# Proposal for GTR#21 revision

~ Expand the application of system bench ~

prepared by Japan

@EVE64

Outline of powertrain system setup ←

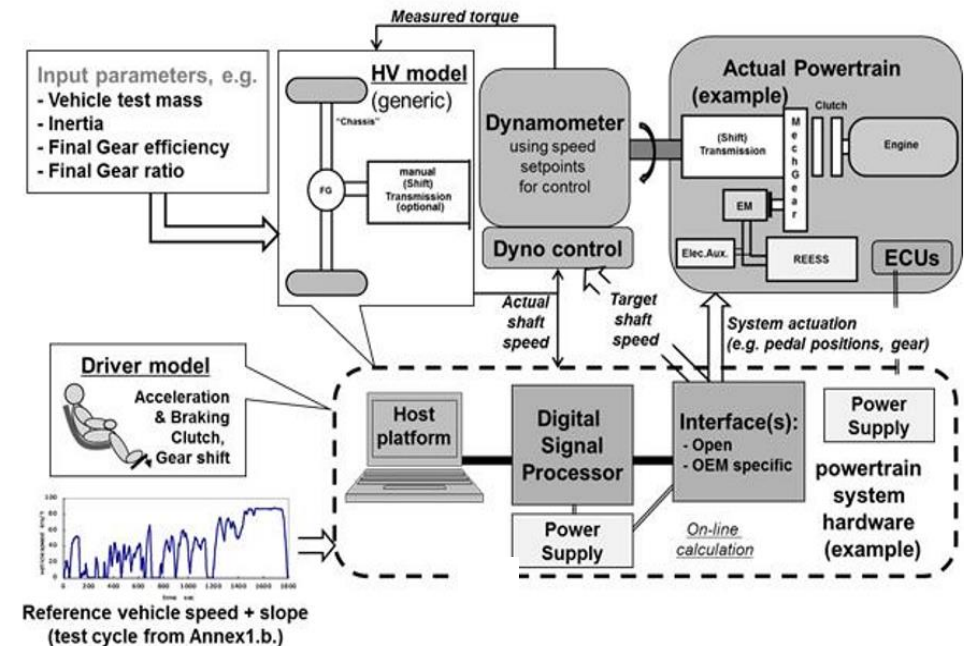
The system bench is also used in the UN-GTR4 powertrain method.

- ✓ The system bench shall consist of the actual powertrain and ECUs of the powertrain.
- ✓ Engine/battery/motor cooling system shall be specified with sufficient cooling capacity to maintain normal operating temperatures.
- ✓ System bench shall duplicate the power loss of the auxiliary devices installed in the vehicle.  
If not the case, the power loss of the auxiliary devices shall be measured independently, then subtracted.
